ZAYO’S PRINEVILLE TO RENO PROJECT

CPUC MINOR PROJECT REFINEMENT FORM

Date Requested: 27 June 2025	Report No.: 22/RFI 506
Date Approved: 7/28/2025	Approval Agency: CPUC (Caltrans approval pending - RFI 506)
Property Owner(s): Caltrans	Location/Milepost: MP M4 - M7.9
Land Use/Vegetative Cover: Ruderal (maintained highway shoulder near edge of pavement)	Sensitive Resources: Requested changes result in avoidance of cultural resources.

Zayo requests to move the running line closer to edge-of-pavement (EOP) between MP M4 - M7.9 (STA 710+32 TO STA 906+28) to avoid a cultural site.

SHEET NO.: 58 of 75

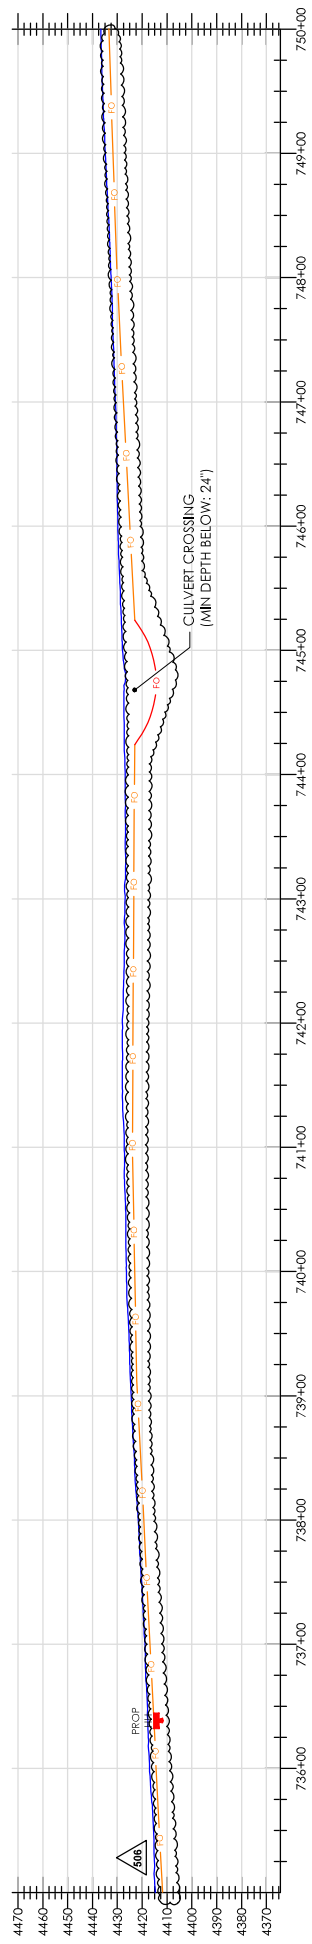
REF: NO. 506
SHIFT R/L CLOSER TO EOP
TO AVOID ANY CULTURAL
SITE
STA 710+32 TO STA 906+28

PLACE (1) 30"x48"x36"
HANDHOLE. LEAVE 100' SLACK
HANDHOLE STATION 736+32
(SEE DETAIL SHEET 4)

BORE UNDER CULVERT
STATION 744+78
(SEE DETAIL SHEET 6)

SHEET NO.: 62 of 75
SCALE: 1"=100'
JOB NUMBER: UPR
DRAWN BY: WP
DATE: 4/8/25

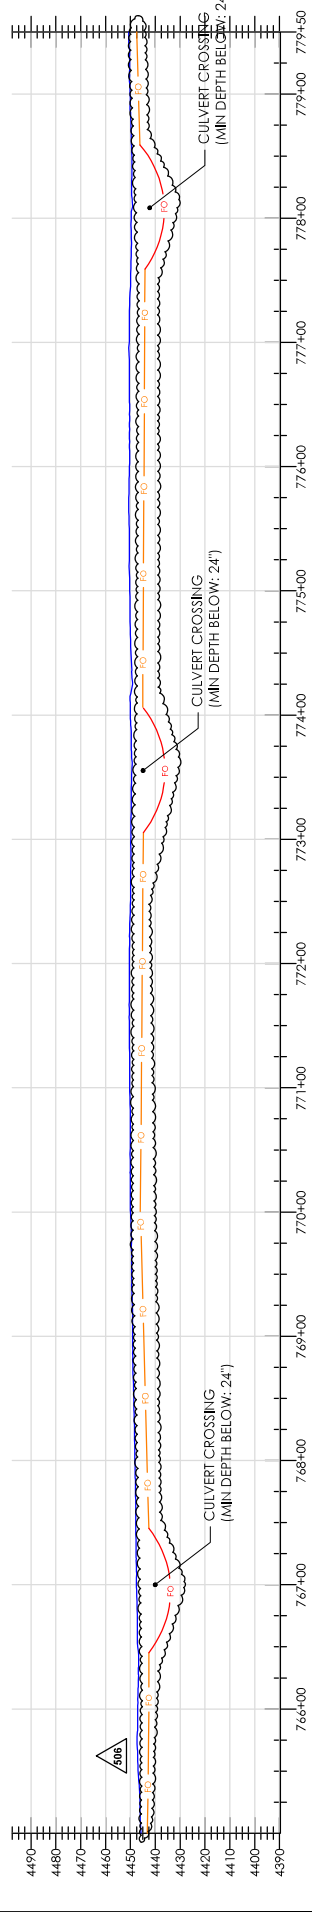
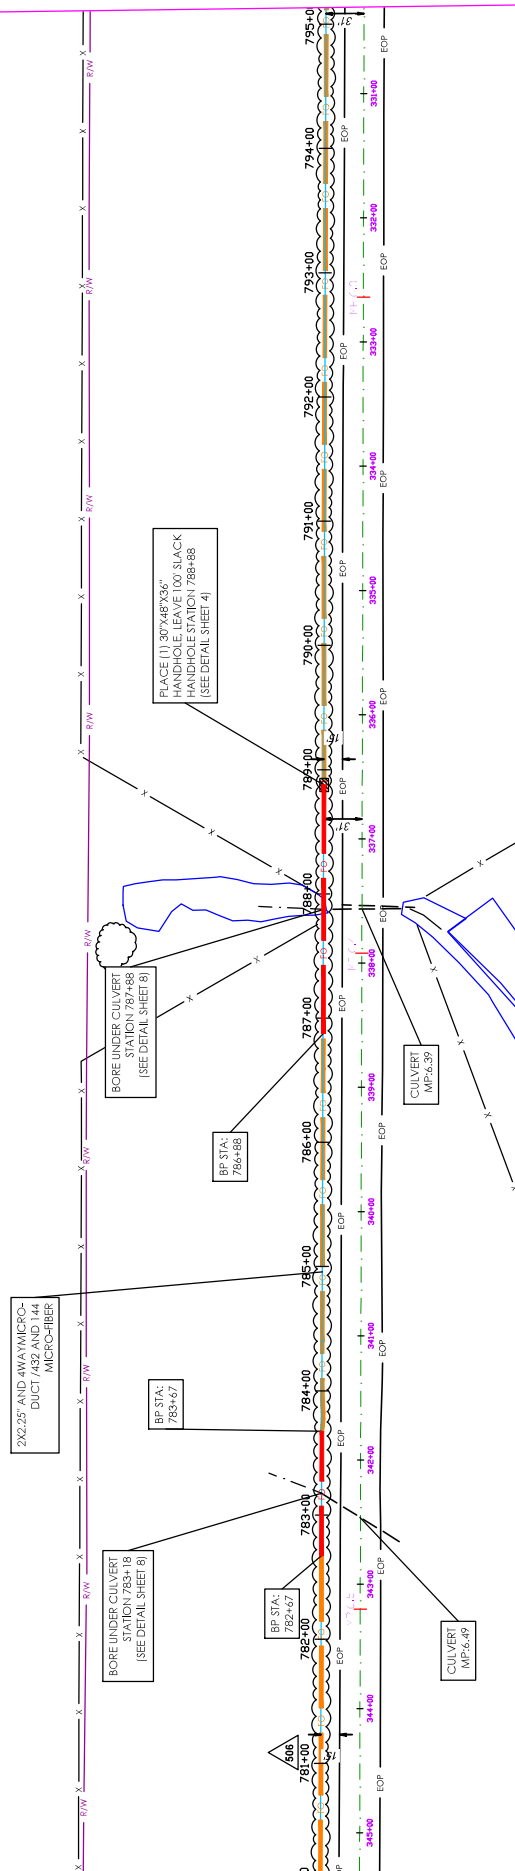
REF. NO. 506
SHIFT R/L CLOSER TO EOP
TO AVOID ANY CULTURAL
SITE
STA 710+32 TO STA 906+28

SHEET NO.: **63 of 75**

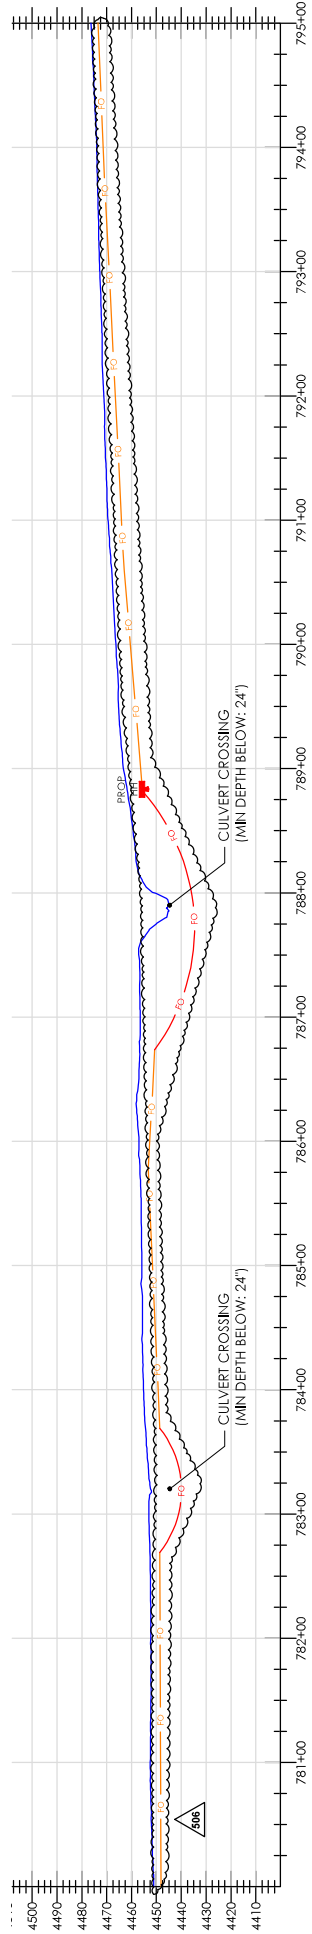
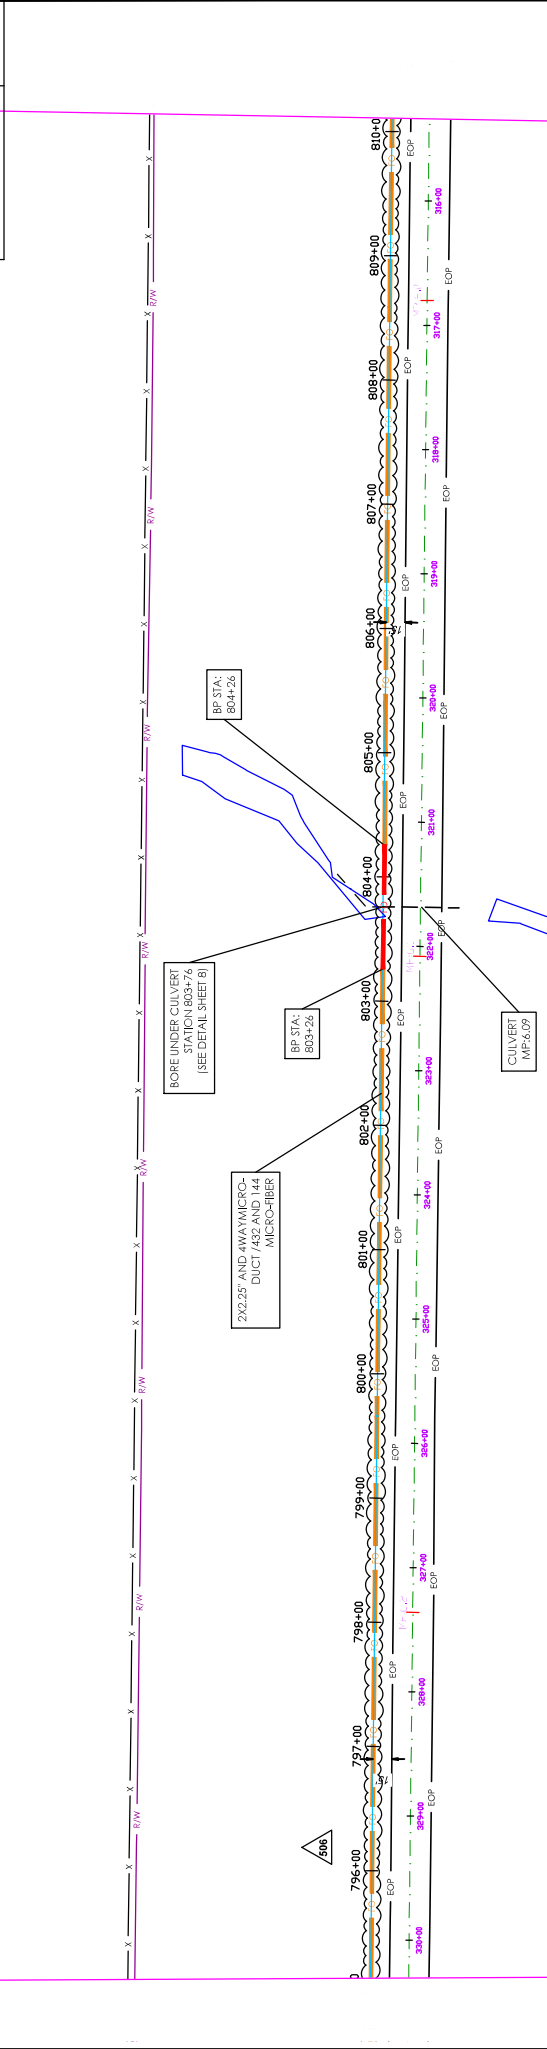
REF NO. 506
SHIFT R/L CLOSER TO EOP
TO AVOID ANY CULTURAL
SITE
STA 710+32 TO STA 906+28

SHEET NO.: 64 of 75

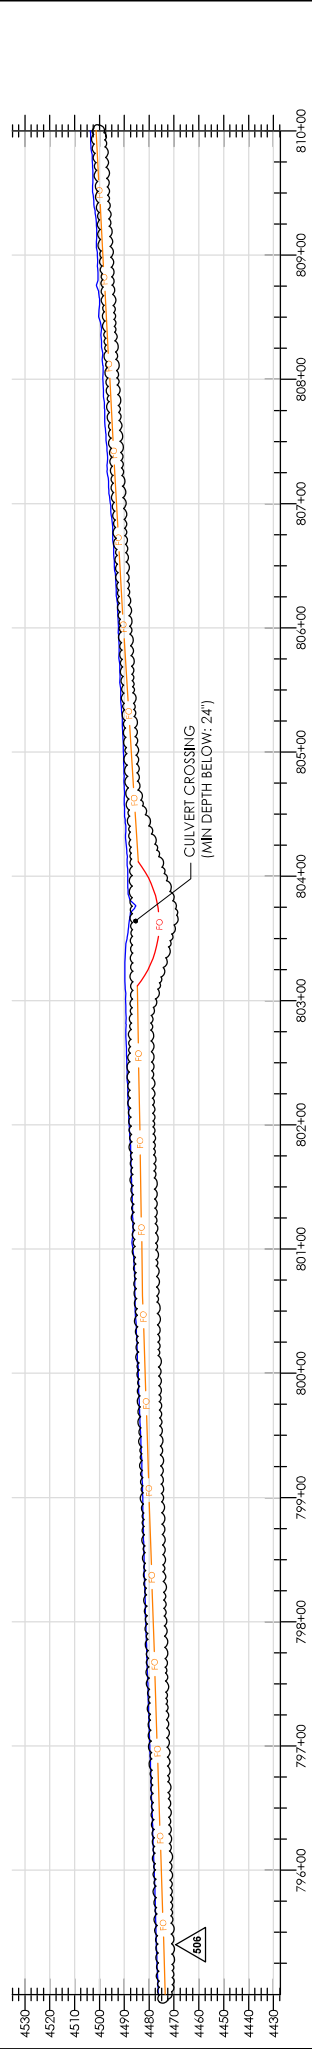
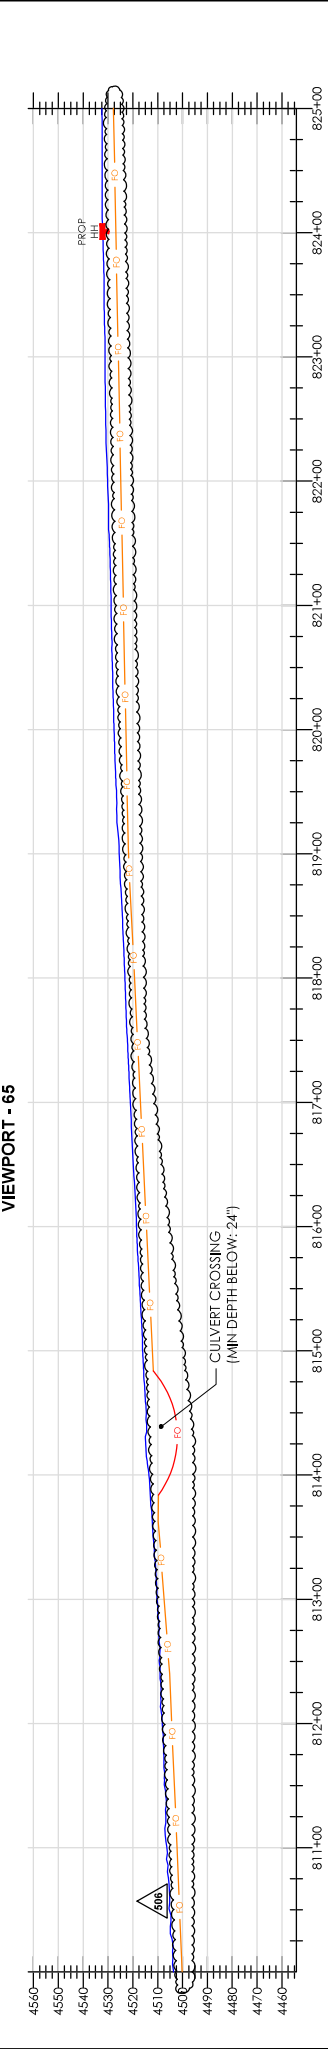
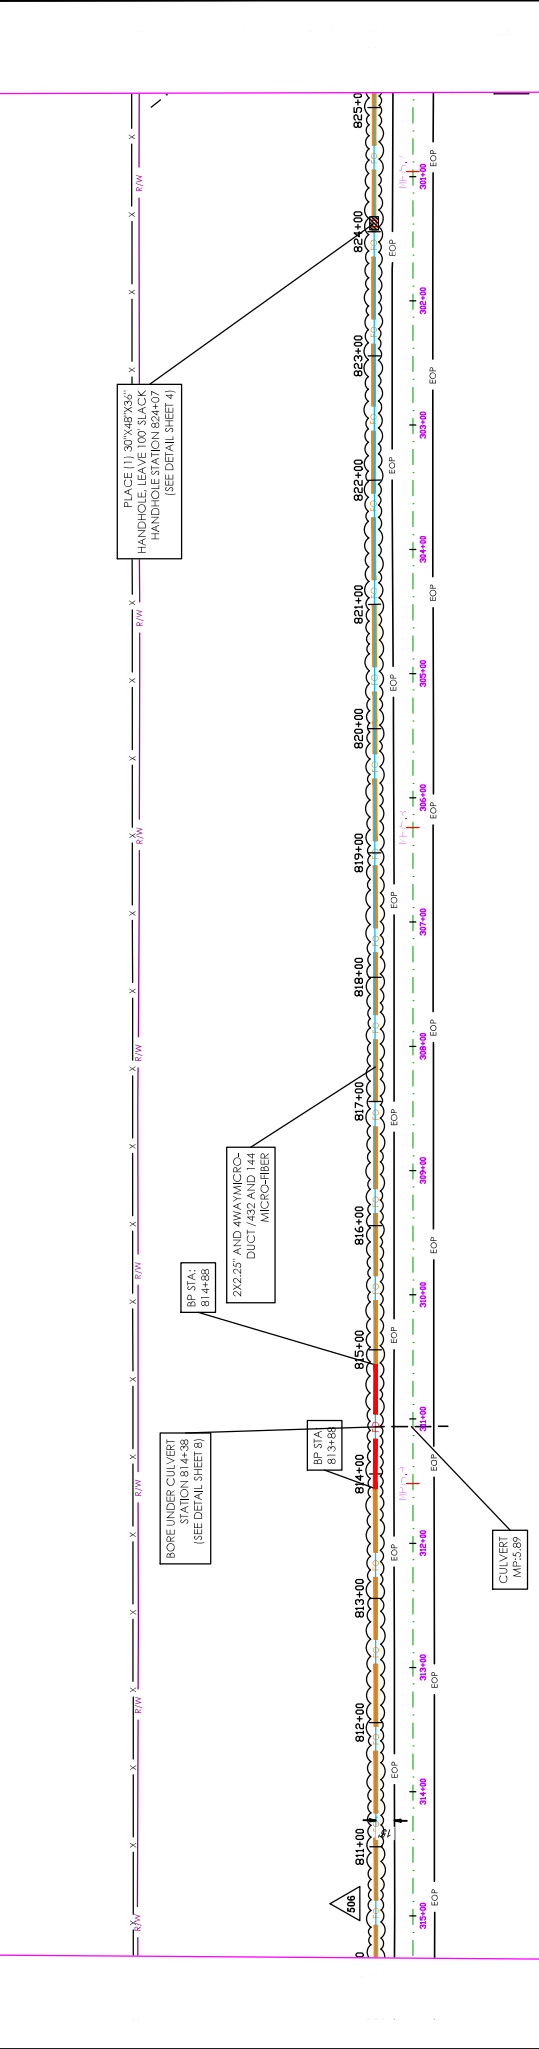
REF. NO. 506
SHIFT R/L CLOSER TO EOP
TO AVOID ANY CULTURAL
SITE
STA 710+32 TO STA 906+28

SHEET NO.: 65 of 75

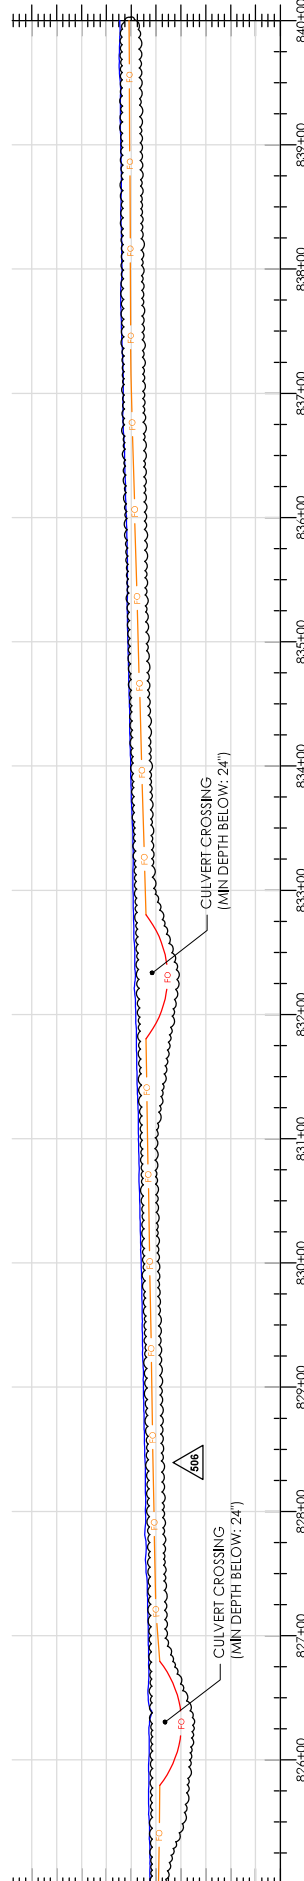
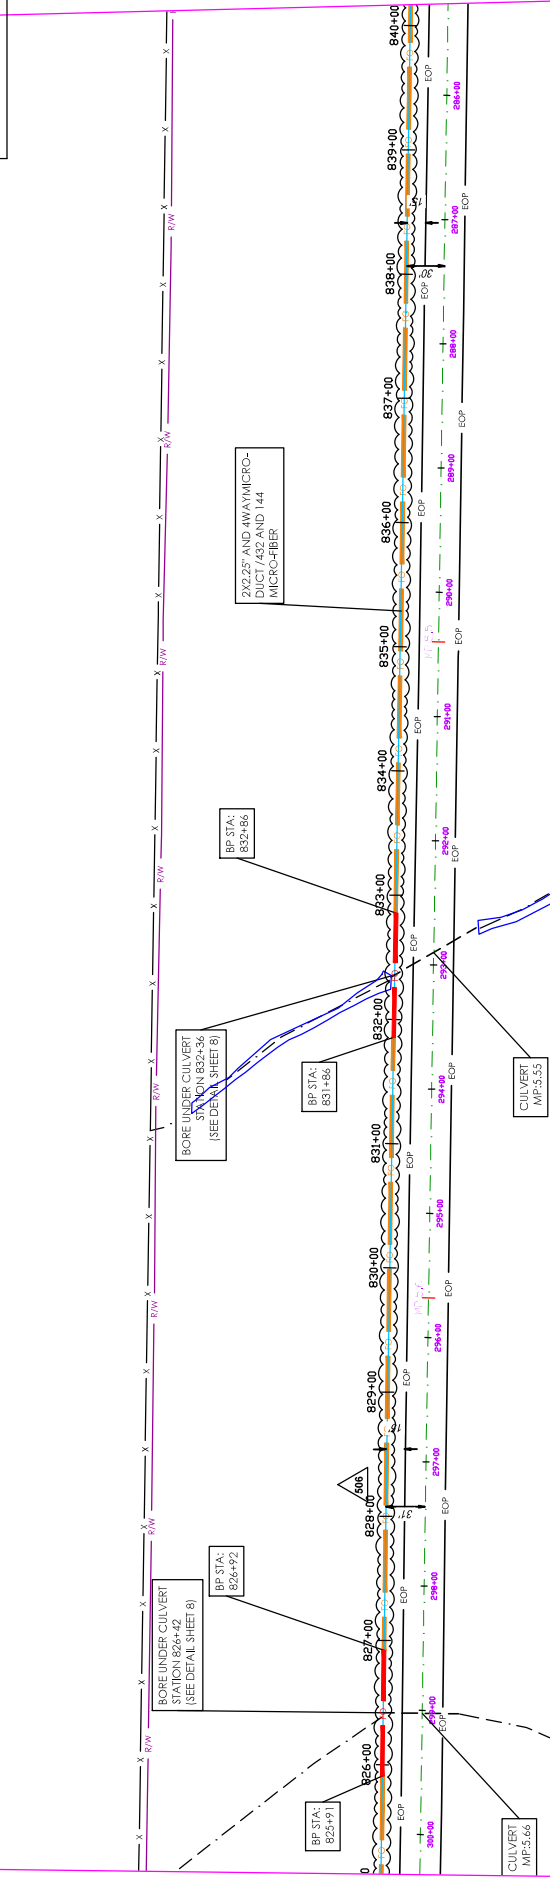
REF NO. 506

SHIFT R/L CLOSER TO EOP

TO AVOID ANY CULTURAL

SITE

STA 710+32 TO STA 906+28

SHEET NO.: 66 of 75

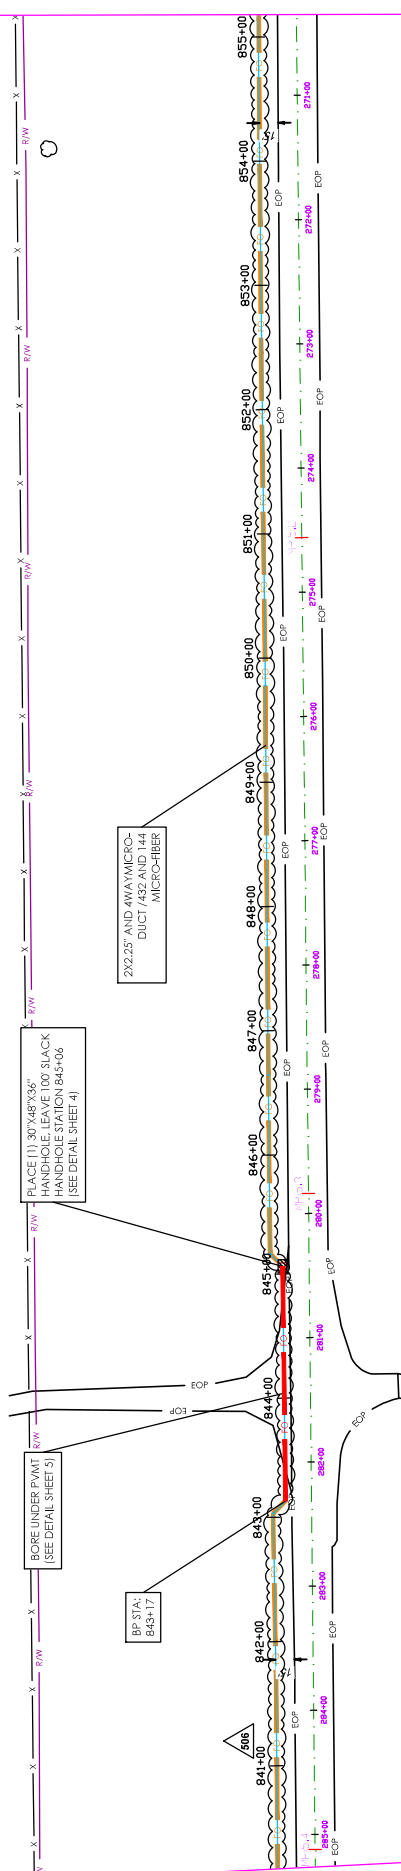
REF. NO. 506
US-395 SHIFT R/L CLOSER TO EOP
(VARIABLE WIDTH RIGHT-OF-WAY)
SITE
STA 710+32 TO STA 906+28

SHEET NO.: 67 of 75

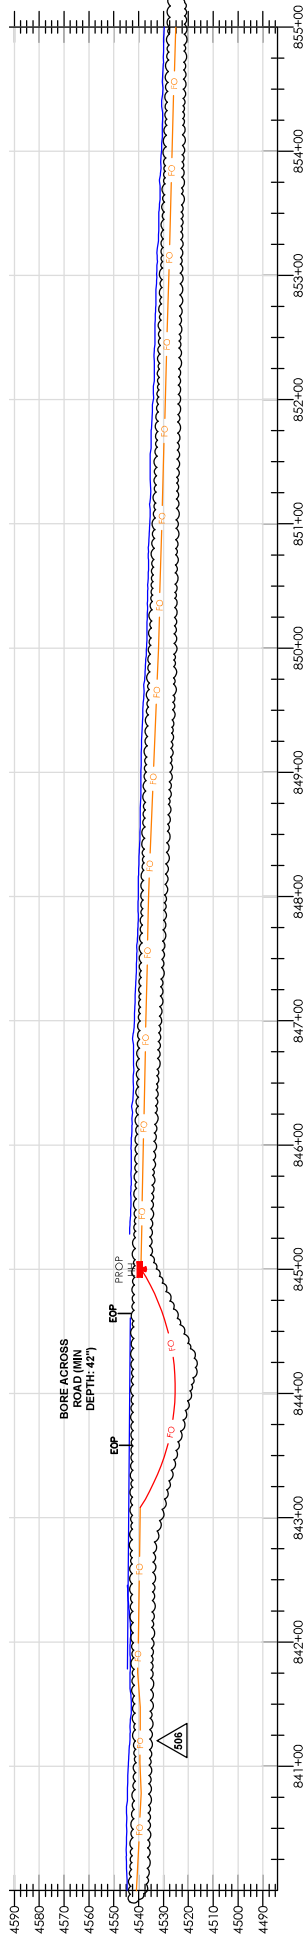
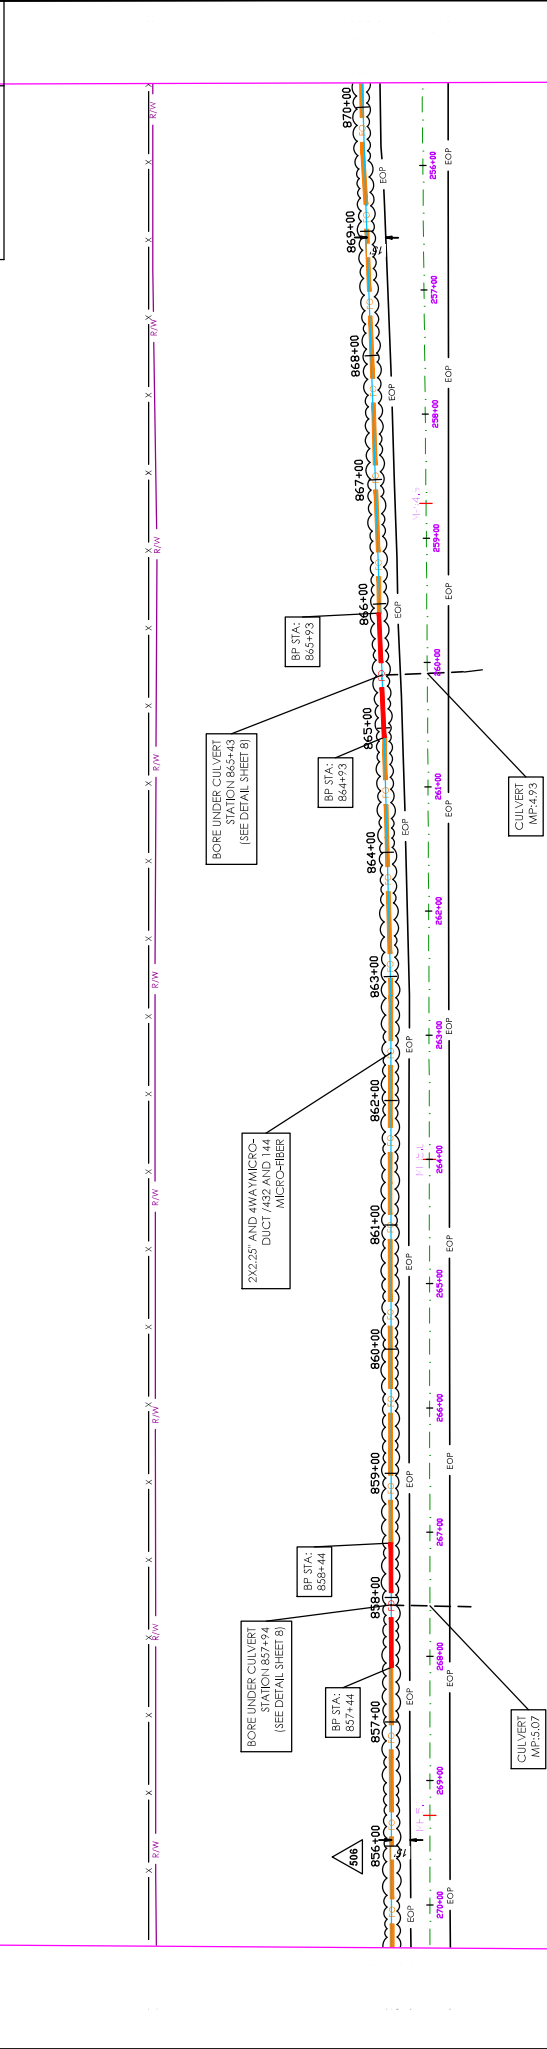
REF NO. 506
SHIFT R/L CLOSER TO EOP
TO AVOID ANY CULTURAL
SITE
STA 710+32 TO STA 906+28
